**PLANNING AND ZONING COMMISSION
REGULAR MEETING
AGENDA**

Wednesday, February 12, 2020

Manor City Hall – Council Chambers
105 E. Eggleston Street

Plat

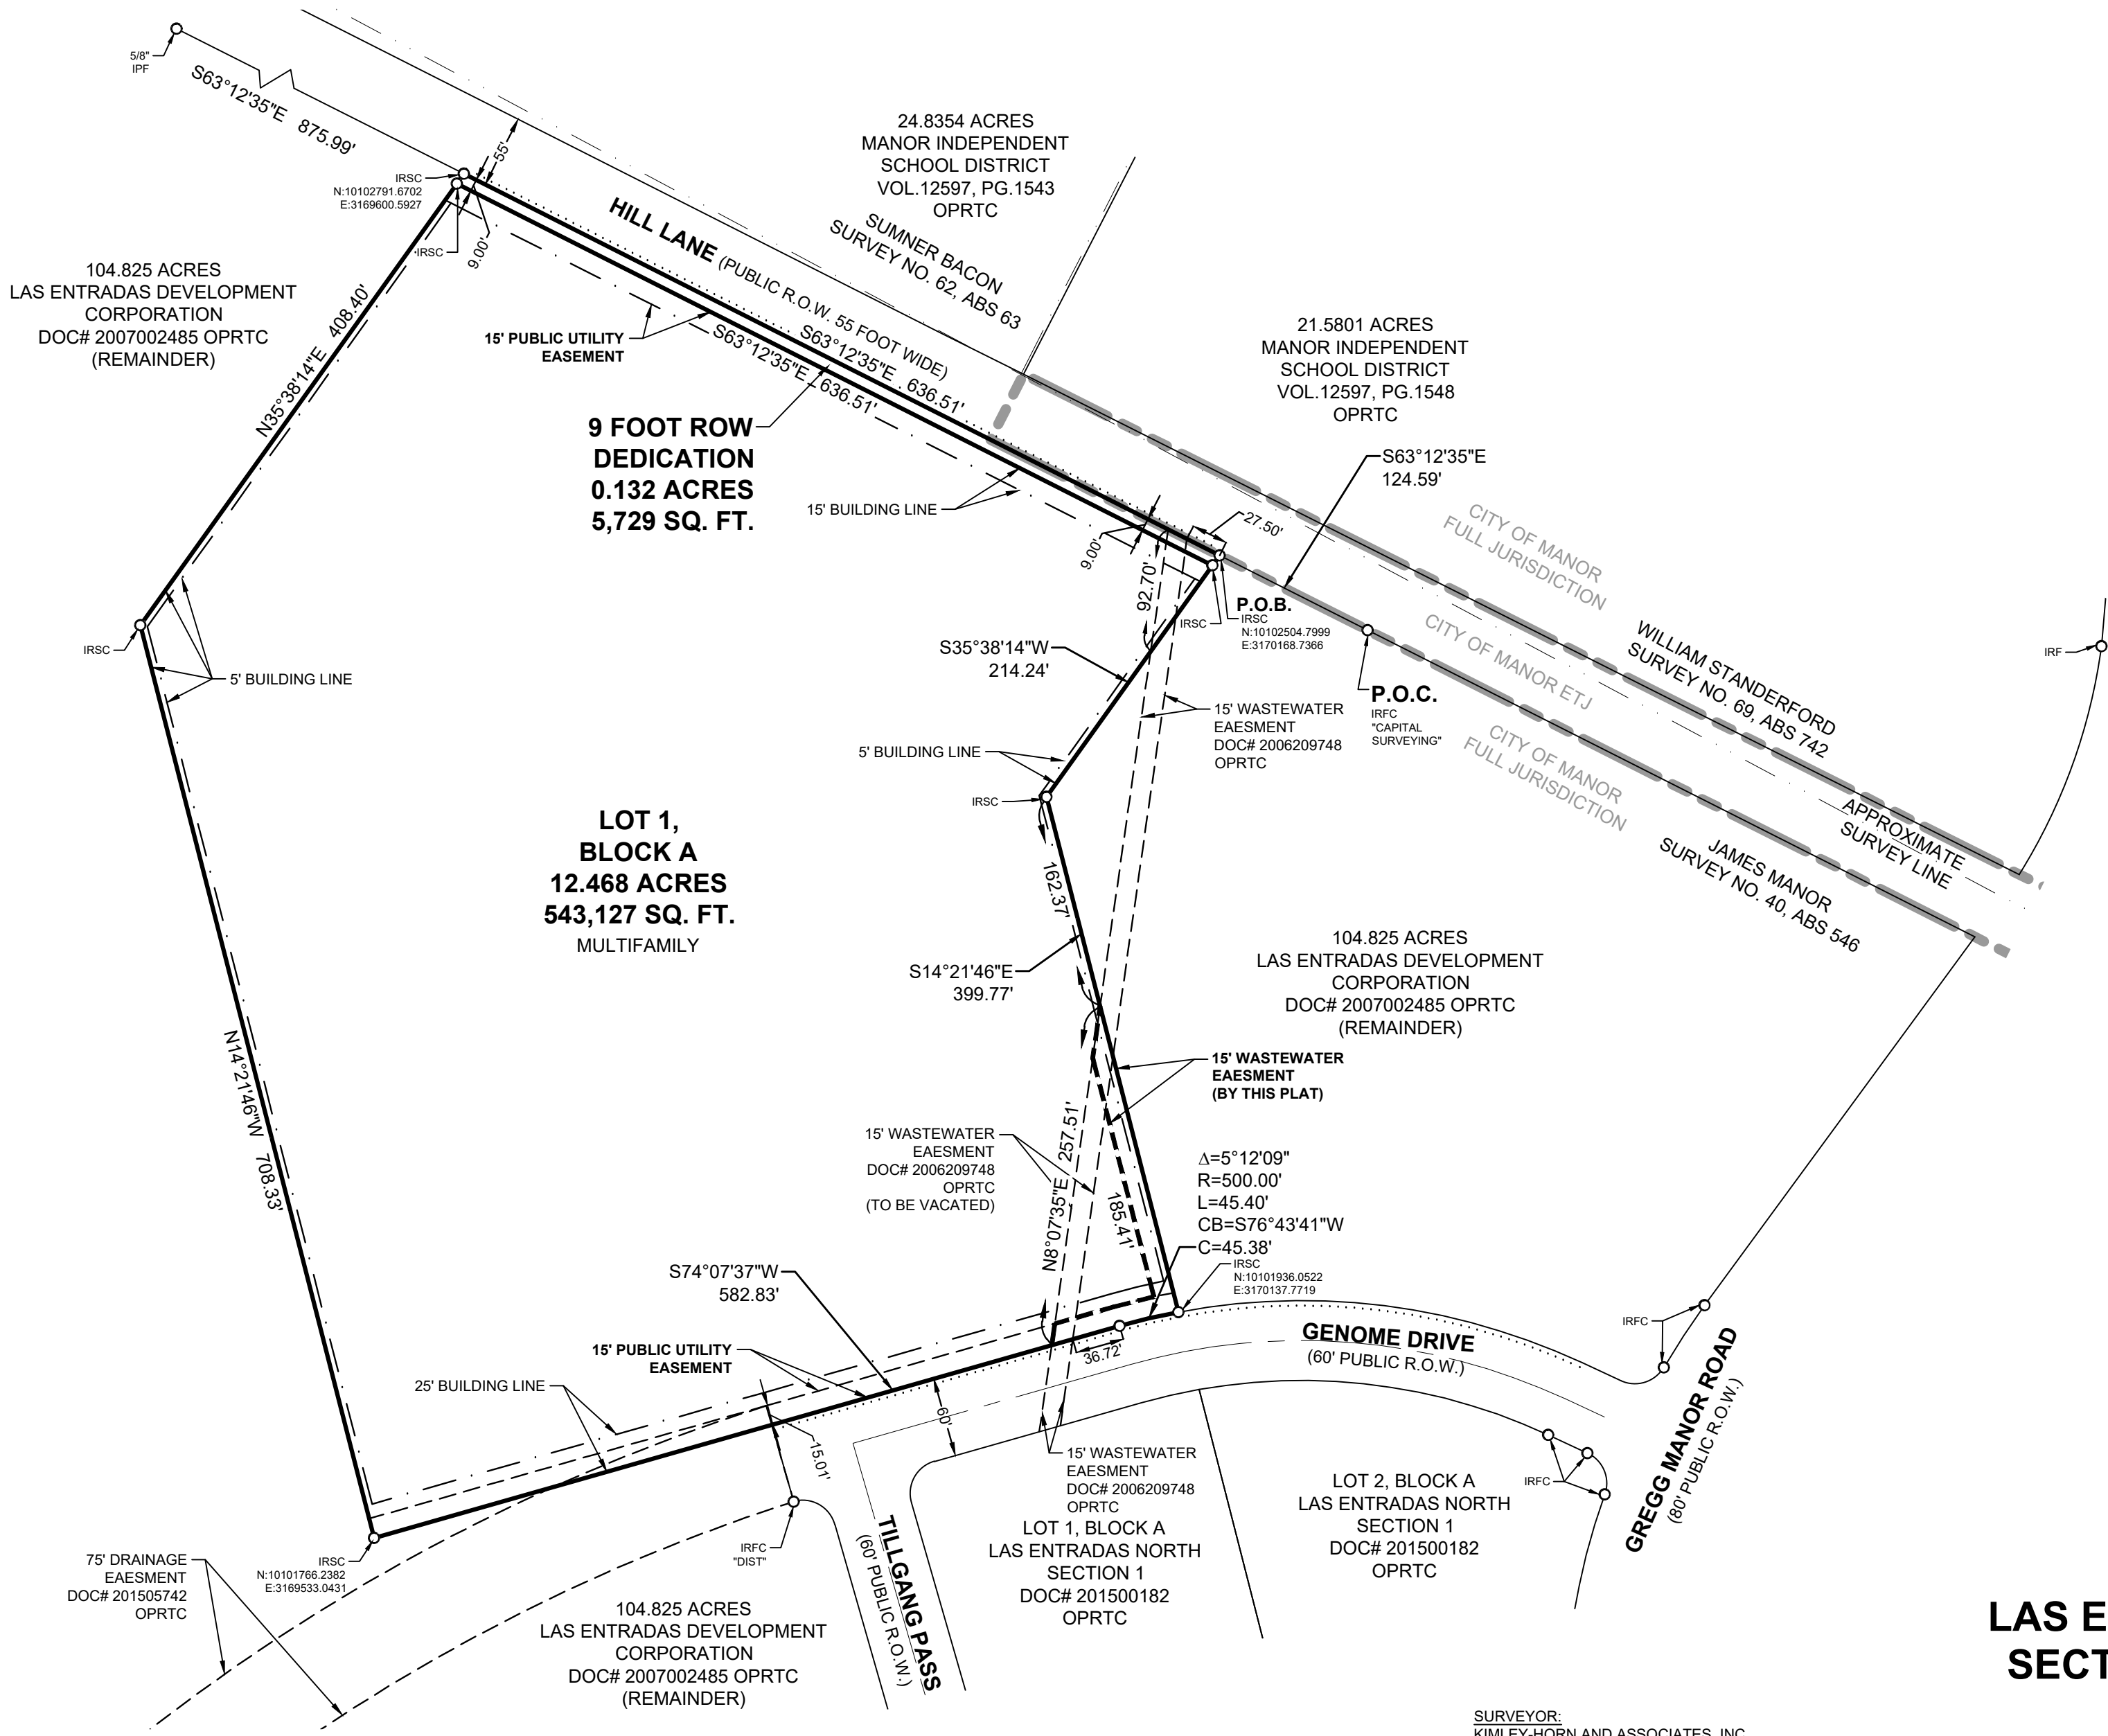
1. Per previous discussions between City Staff, the developer and the developer's engineer, a submittal showing that no offsite drainage is required for the project should be submitted in order to verify that the final plat meets short form final plat submittal requirements.

2. The Mayor's name should be added to the signature block. It is Dr. Larry Wallace, Jr.
3. Note that content requirements for Short Form Final Plats shall correspond with the required content of Final Plats.

6. Provide information regarding what entity will provide water and wastewater to the proposed lot.
7. Clearly show where the existing 75' drainage easement is located on the proposed property.

8. Clarify if the existing wastewater easement is proposed to be totally vacated or partially vacated.
9. A release of easement (or partial release of easement vacating the easement will need to be submitted for review. Field notes and a sketch will need to be provided as part of the release. The vacation of the easement will need to be approved by City Council.

10. The wastewater easement vacation document will need to be recorded prior to recordation of the final plat.
11. The City Secretary is Lluvia Almaraz.
12. The Notary's Signature Block lists the year as 2019.
13. Remove references to underground stormwater drainage facilities in General Note 1. The drainage facilities will be private and will not be maintained by the City.
14. General Note 3 should say approved by the City of Manor.
15. Remove references to underground stormwater drainage facilities in General Note 5. The drainage facilities will be private and will not be maintained by the City.
16. Modify General Note 7 to reference the multifamily project not single family.
17. Delete General Note 8 as no streets will be constructed.
18. Delete General Note 9 as sidewalks are to be installed with the project.
19. The description of the wastewater easement should be:

Response: Drainage sheets from submitted site plan are attached.

Response: The Mayor's name has been added.

Response: Note 4 has been added to the plat stating water and wastewater service.

Response: Dimensions have been added to the drainage easement.

Response: Partially vacated. Description of vacated easement has been attached with this submittal.

Response: Noted. Description of vacated easement has been attached with this submittal.

Response: City secretary's name has been revised.

Response: The date on the notary's signature block has been updated.

Response: This note has been revised.

Response: References have been removed.

Response: General Note 8 has been deleted.

Response: General Note 9 has been removed.
